# HOUSTON PLANNING COMMISSION

## AGENDA

MARCH 29, 2018

# Houston Planning Commission ITEM: 114

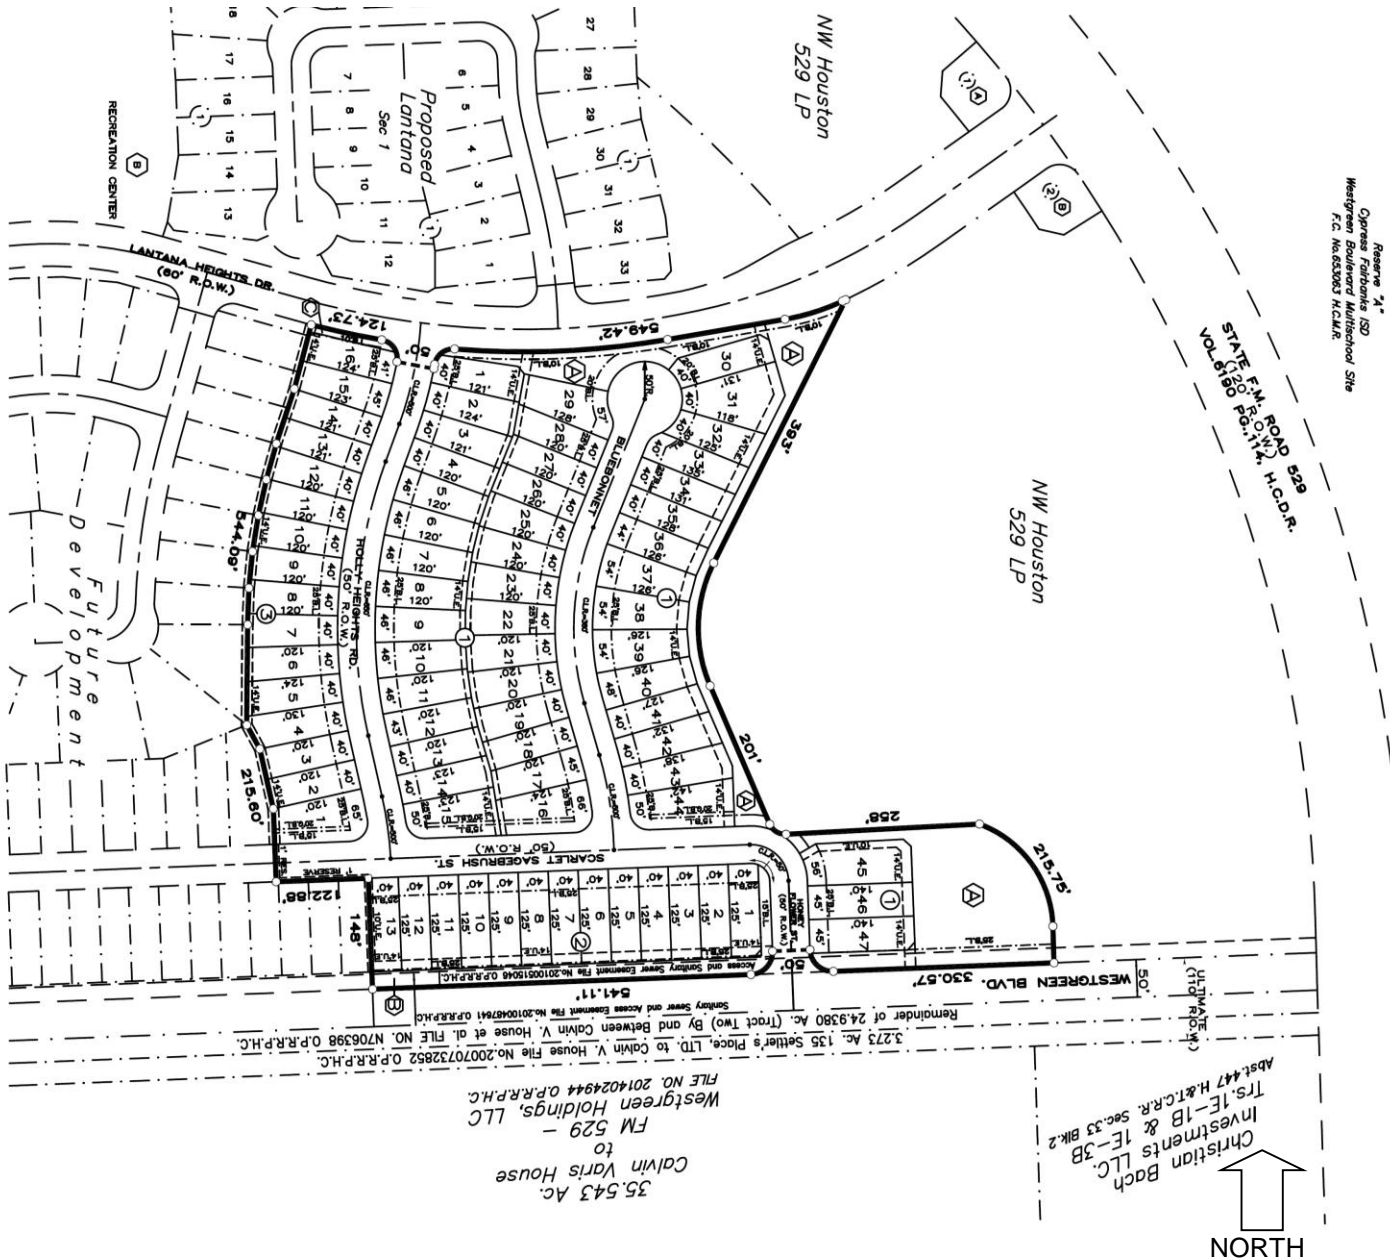
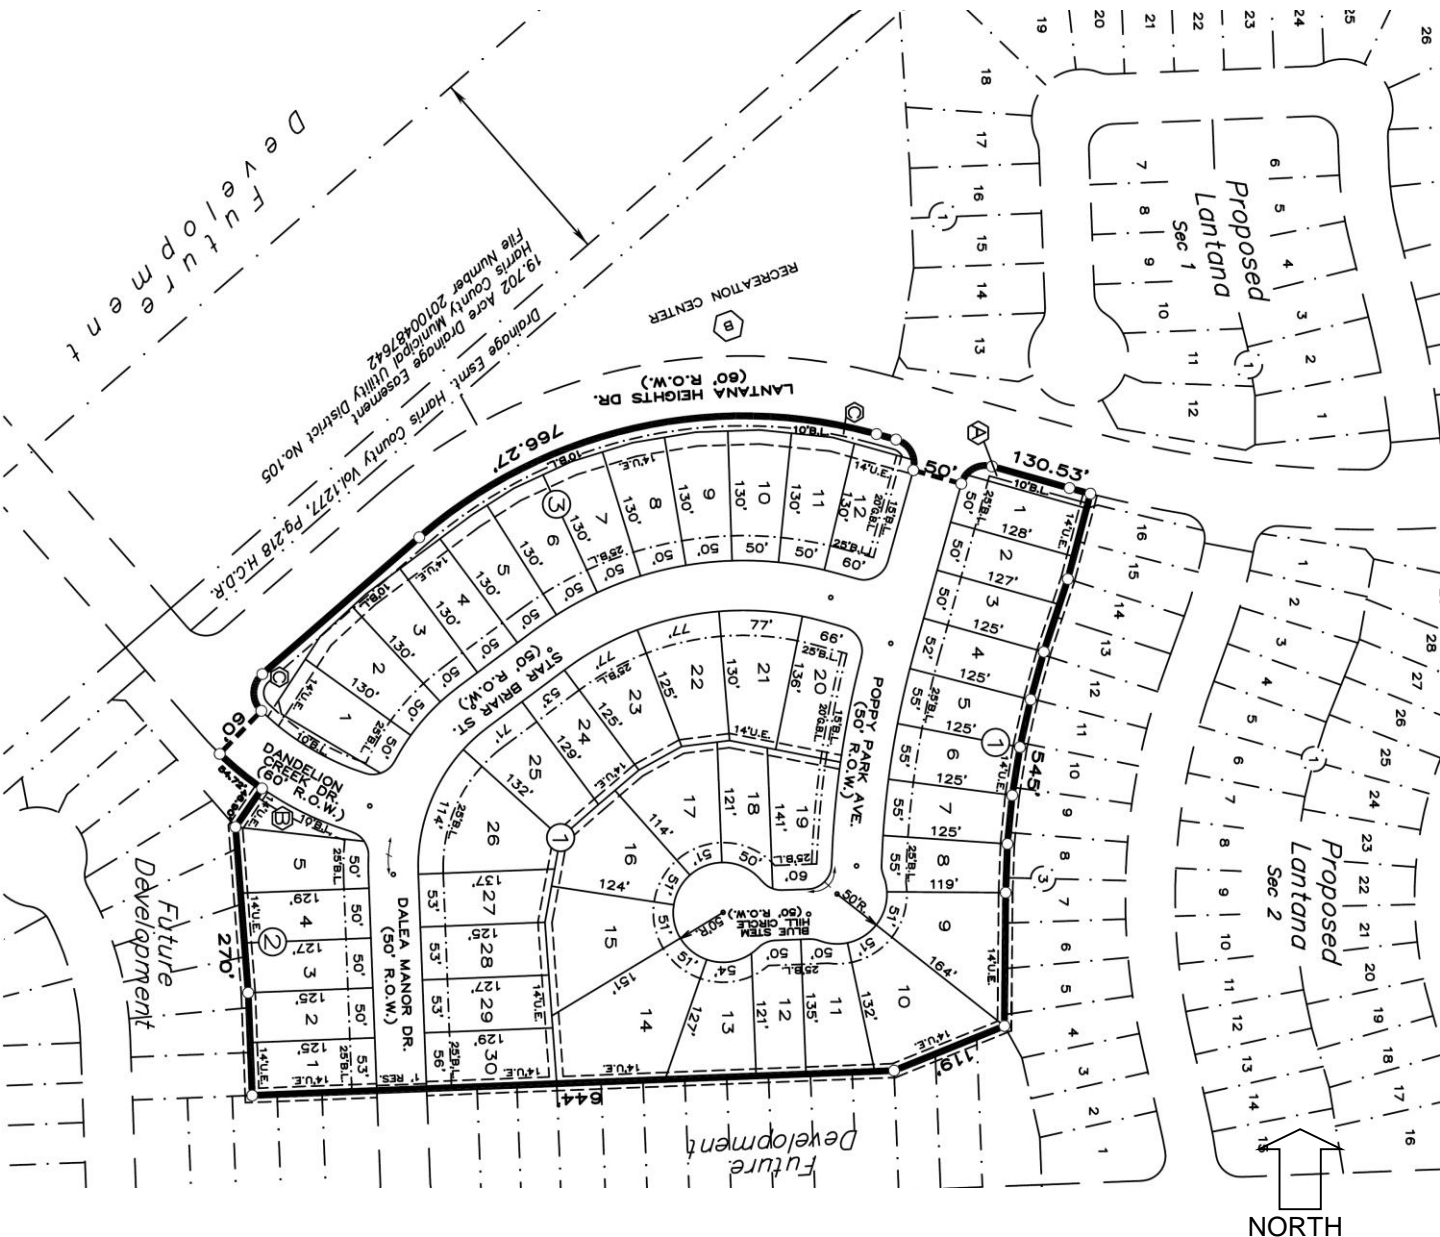
Plat is requested to be deferred until meeting is held with planners/developers on both sides of Westgreen to determine dedication and construction responsibilities

UVE should be checked at Dandelion Creek Dr and Lantana Heights Dr, and at Poppy Park Ave and Lantana Heights Dr.
